builder

**SMITH
RESIDENCE
HOUSTON, TX**

**ELECTRICAL
PLAN
FIRST FLOOR**

● #511 - update to prados

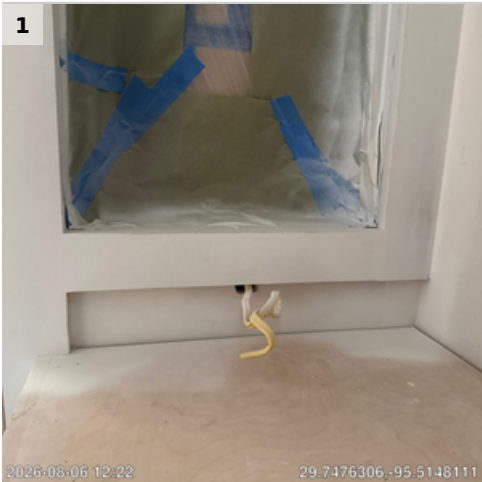
Abby Antoniou	Photo 1 - GPS: 29.7476306, -95.5148111	06 Aug 12:22 PM
Abby Antoniou	Photo 2 - GPS: 29.7476278, -95.5148111	06 Aug 12:22 PM
Abby Antoniou	we have about 2 inches when the counter goes in	06 Aug 12:24 PM
Abby Antoniou	Photo 3 - GPS: 29.7474556, -95.5148556	06 Aug 12:24 PM
Abby Antoniou	Photo 4 - GPS: 29.7474944, -95.5147861	06 Aug 12:25 PM

#308 - Change to Prado with ring

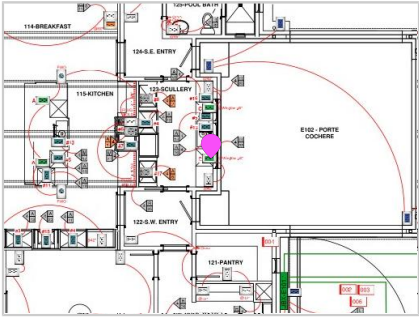
both here and fireplace mantel

need to move - need to send silvestre spec

may switch to Prados - TBD, waiting on John

Switch to Prado with ring. All Prado with rings.

Silvestre, these are going to be prados now

#329 - Move outlets up

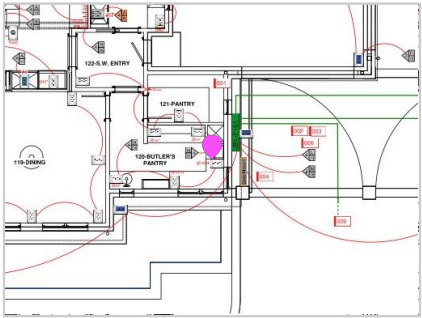
Abby Antoniou	Photo 1	20 Jan 02:41 PM
Abby Antoniou	Photo 2 - GPS: 29.7475258, -95.5148525	03 Feb 10:30 AM
Abby Antoniou	Photo 3 - GPS: 29.7475258, -95.5148525	03 Feb 10:30 AM
Abby Antoniou	Where did the other outlet go?	04 Feb 11:55 AM
Abby Antoniou	Photo 4 - GPS: 29.7477764, -95.514385	23 Mar 11:09 AM
Abby Antoniou	Silvestre wants to know exactly where we want to put them	06 Aug 11:40 AM
Abby Antoniou	Photo 5 - GPS: 29.7476278, -95.5146056	06 Aug 11:40 AM
Abby Antoniou	Photo 6 - GPS: 29.7476278, -95.5146056	06 Aug 11:40 AM
Abby Antoniou	Move up right below counter space, add grommet	06 Aug 04:50 PM
Abby Antoniou	Photo 7 - GPS: 29.7477472, -95.514475	19 Oct 01:57 PM
Abby Antoniou	Photo 8 - GPS: 29.7477444, -95.5144722	19 Oct 01:57 PM
Abby Antoniou	just waiting for grommet to be added @ future date	19 Oct 01:58 PM

● **#377 - Prado on side panels of the Millwork. Will need to box around wires on the inside. Coordinate with builder and carpenter**

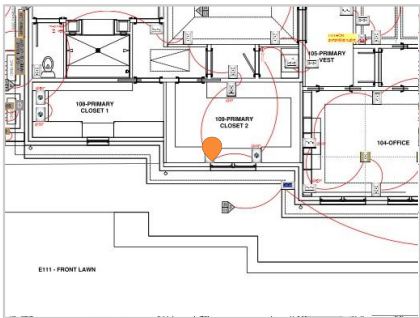
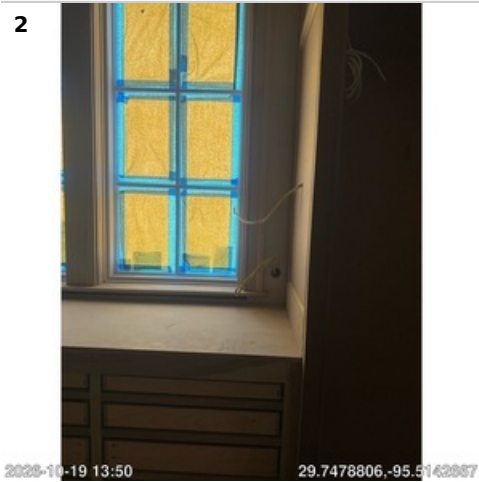
Andy Tate	Photo 1 - GPS: 29.7481459, -95.5148464	17 Mar 10:20 AM
Abby Antoniou	Talked to electrician	06 Aug 11:54 AM
Wynne Walker	There isn't room in the sides, John wants to move them to the sheetrock wall.	10 Aug 02:30 PM
Abby Antoniou	Photo 2 - GPS: 29.7478806, -95.5142667	19 Oct 01:50 PM
Wynne Walker	Confirm the part number includes the Sheetrock plate for these two	20 Oct 10:10 AM
Abby Antoniou	On the electrical plan currently, all Prados are spec'd as 9000-0003, which is just the single unifit outlet with no trim clarification. We do not have anything in iPoint yet. Need to discuss	21 Oct 03:18 PM

#514 - Try to put in millwork panel?

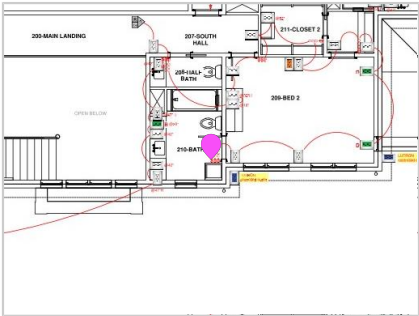
Abby Antoniou	Photo 1 - GPS: 29.7474944, -95.5150278	06 Aug 12:32 PM
Abby Antoniou	We are trying to figure out where to out the dimmers. Will we be able to box out to put them in the millwork panel?	13 Aug 02:10 PM
Abby Antoniou	Still need to figure this out	20 Oct 09:39 AM

● **#528 - Ask client if they want to remove side outlets**

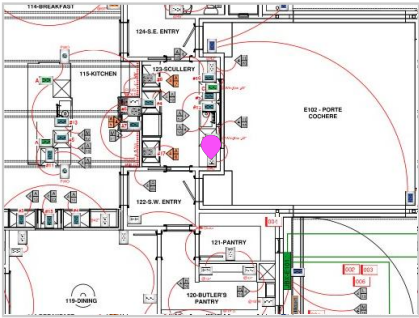
Change to plug mold

● **#525 - Move outlets to back Sheetrock wall. Not in millwork. Need Prado with mud plate .**

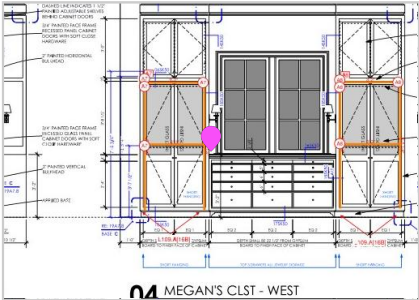
I have the mud plate to John to try

● **#491 - Outlet not centered (we did not show it centered!)**

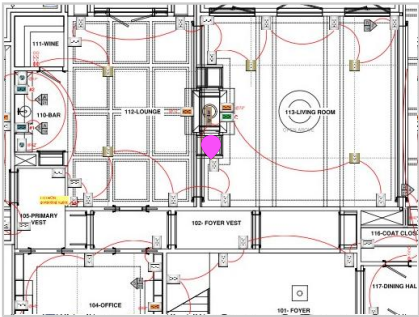
Another example of a poorly placed outlet on our plan. Maybe we need EQ lines like on lighting? John said they will correct it.

● #437 - Ask John if there is still a medicine cabinet here

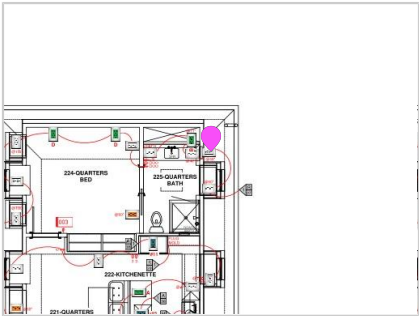
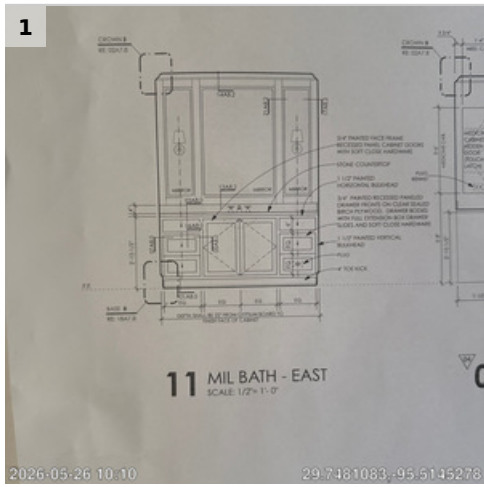
Wynne Walker	"Add / move plug up to middle drawer instead of bottom "	15 Apr 10:15 AM
	That is from their email. I don't even show a drawer outlet here.	
Abby Antoniou	I'm pretty sure this was for a medicine cabinet	15 Apr 10:15 AM
Wynne Walker	oh yea, thanks	29 Apr 05:23 PM
Wynne Walker	I guess they want to add a docking drawer ... need to confirm with builder.	29 Apr 05:24 PM
Abby Antoniou	add docking drawer	26 May 10:10 AM
Abby Antoniou	Photo 1 - GPS: 29.7481083, -95.5145278	26 May 10:10 AM
Abby Antoniou	Photo 2 - GPS: 29.7476444, -95.5141611	09 Jun 10:13 AM
Abby Antoniou	Ask John if they are still doing a medicine cabinet here	06 Aug 12:51 PM
Abby Antoniou	Photo 3 - GPS: 29.747825, -95.5140611	06 Aug 12:52 PM
Abby Antoniou	add docking drawer to plan	06 Aug 12:52 PM

● #512 - they are moving these to be in the side of the millwork

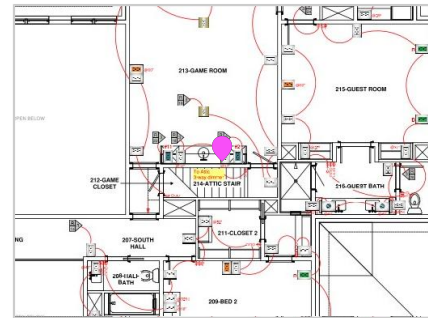
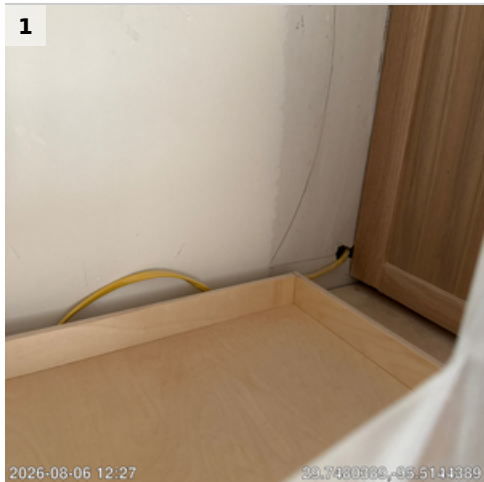
Abby Antoniou	Photo 1 - GPS: 29.7480389, -95.5144389	06 Aug 12:27 PM
Abby Antoniou	Photo 2 - GPS: 29.7480417, -95.5144389	06 Aug 12:27 PM
Abby Antoniou	they are moving these to be in the side of the millwork	06 Aug 12:28 PM
Wynne Walker	Need to confirm with designer and builder. There isn't enough depth on the sides unless they box it out.	10 Aug 11:40 AM
Abby Antoniou	still need to confirm with John	19 Oct 02:09 PM
Wynne Walker	Change to Prado in wallpaper. Need mud flange.	20 Oct 11:14 AM

#7 - Change to single prado outlet

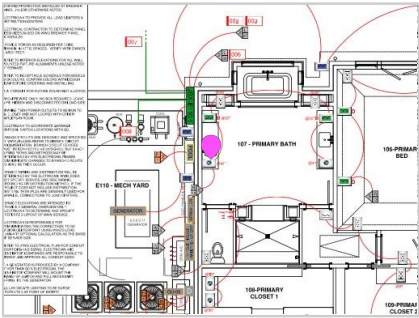
Abby Antoniou	Photo 1 - GPS: 29.7482306, -95.51465	06 Aug 11:56 AM
Abby Antoniou	Electrician to fix	06 Aug 11:56 AM
Abby Antoniou	still needs to be done	19 Oct 01:51 PM

#5 - Change to single Prado outlet

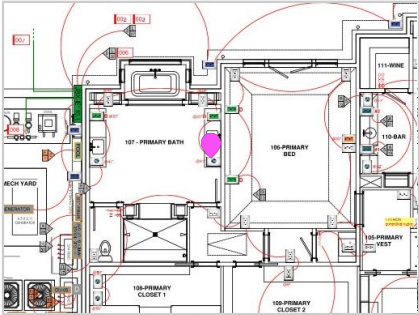
Abby Antoniou	Photo 1 - GPS: 29.7482389, -95.5145667	06 Aug 11:55 AM
Abby Antoniou	Electrician to fix	06 Aug 11:56 AM
Abby Antoniou	still needs to be done	19 Oct 01:51 PM

● #489 - Center keypad

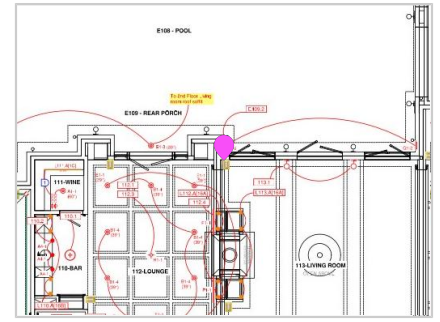
Wynne Walker	Photo 1 - GPS: 29.7480028, -95.5145861	05 Aug 02:22 PM
Wynne Walker	Photo 2 - GPS: 29.7477389, -95.5143889	05 Aug 02:22 PM
Abby Antoniou	Still needs to be done	19 Oct 01:44 PM
Wynne Walker	I spoke with the carpenter about this	20 Oct 10:41 AM

#493 - Cove section detail

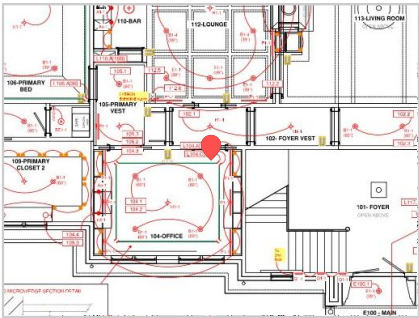
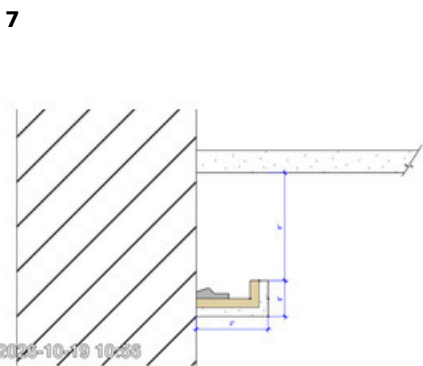
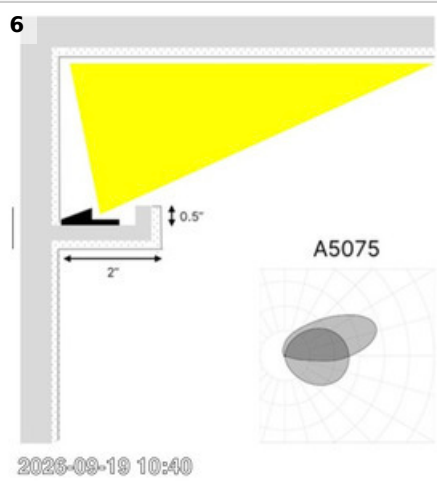
#549 | Completed | Figure out how to get the wires down to the ledge and add a shim for the light. See section detail.

Wynne Walker	Photo 1 - GPS: 29.7420889, -95.5179056	05 Aug 04:58 PM
Wynne Walker	Photo 2 - GPS: 29.7508861, -95.516075	05 Aug 04:58 PM
Wynne Walker	We need to mock up the Xico and regular tape ASAP	15 Sep 10:58 AM
Wynne Walker	Xico worked better	19 Sep 10:35 AM
Wynne Walker	Photo 3	19 Sep 10:35 AM
Wynne Walker	Photo 4	19 Sep 10:35 AM
Wynne Walker	Photo 5	19 Sep 10:35 AM
Wynne Walker	We need a new section detail for this fixture. See first photo above.	19 Sep 10:35 AM
Wynne Walker	Photo 6	19 Sep 10:40 AM
Wynne Walker	This is their standard detail.	19 Sep 10:41 AM
Abby Antoniou	Photo 7	19 Oct 10:56 AM
Abby Antoniou	Do you want this on the lighting plan?	19 Oct 10:56 AM
Wynne Walker	I dont think it helps now. Better to print this out and hand it to John to ensure it's done correctly	21 Oct 11:13 AM

● #478 - Need final spec on these lights ASAP. They will be in Wood.

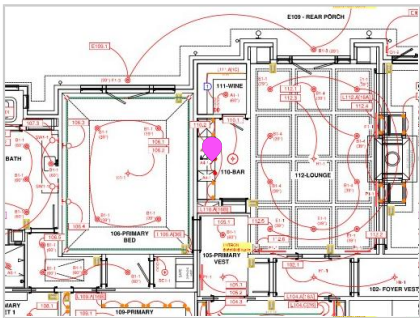
Wynne Walker	Eterna 1”?	28 Jul 09:05 AM
Wynne Walker	Let’s go with Eterna 1” here. Need to give John the hole size to cut out.	28 Jul 11:37 AM
Wynne Walker	Changing to Zaniboni Stella 1 X. Please update schedule.	30 Jul 03:36 PM
Abby Antoniou	Lighting plan is updated -- please review part # when you have the chance @WynneWalker	04 Aug 03:47 PM
Wynne Walker	D1-STE1X-09-30-C-5-L-WS-E0-00-D	05 Aug 06:20 PM
	L is for cross louver	
Wynne Walker	dont forget these are moving forward in line with the edge of the counter	10 Aug 09:25 AM
Wynne Walker	Change to two and move slightly closer together.	11 Aug 04:48 PM
Wynne Walker	Sorry, but change back to 3.	18 Aug 10:49 AM
Wynne Walker	I think the part number may be just slightly different. I'm waiting for confirmation from Ed.	28 Aug 10:49 AM
Wynne Walker	Photo 1 - GPS: 29.7468722, -95.5145194	22 Sep 10:11 AM
Wynne Walker	Photo 2 - GPS: 29.7477722, -95.5143278	22 Sep 10:11 AM

Worried holes may be slightly too large. Need sample light.
I gave John the sample today so he can correct these if they need to be fixed.

#244 - move WAP wires

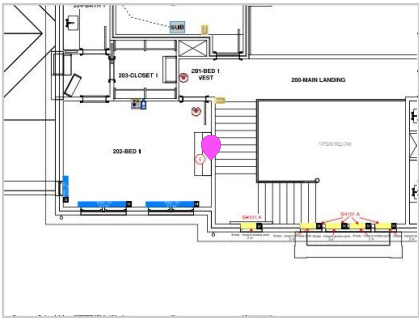
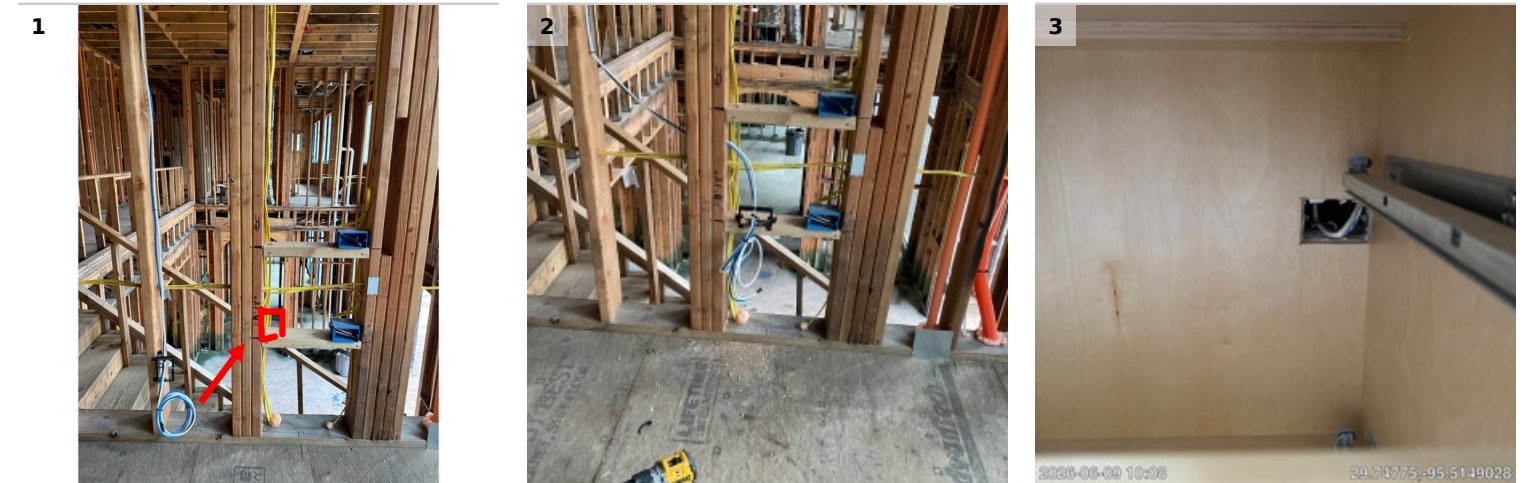
Abby Antoniou	Photo 1	22 Jan 02:57 PM
Armando Hernandez	Photo 2 - GPS: 29.747762, -95.5147934	23 Jan 01:46 PM
Wynne Walker	Abby, will you take a picture of this next time you are there?	27 May 11:42 AM
Abby Antoniou	Received, yes	27 May 11:50 AM
Abby Antoniou	Photo 3 - GPS: 29.74775, -95.5149028	09 Jun 10:08 AM
Abby Antoniou	Photo 4 - GPS: 29.7477528, -95.5149028	09 Jun 10:08 AM
Wynne Walker	The outlet above the counter is not located well. We have to pay more attention. It would be better centered or off to one side. Maybe even one at both side.	09 Jun 06:31 PM
Wynne Walker	The wireless access point will not mount that close to the bulkhead. Maybe we should mount it in the knee space next to the outlet. I will need to look at it.	09 Jun 06:31 PM
Abby Antoniou	Photo 5 - GPS: 29.7478889, -95.5151556	18 Jun 02:06 PM
Abby Antoniou	Lmk your thoughts	18 Jun 02:06 PM
Abby Antoniou	Let them know to mount it to bulkhead down the road	26 Jun 02:02 PM
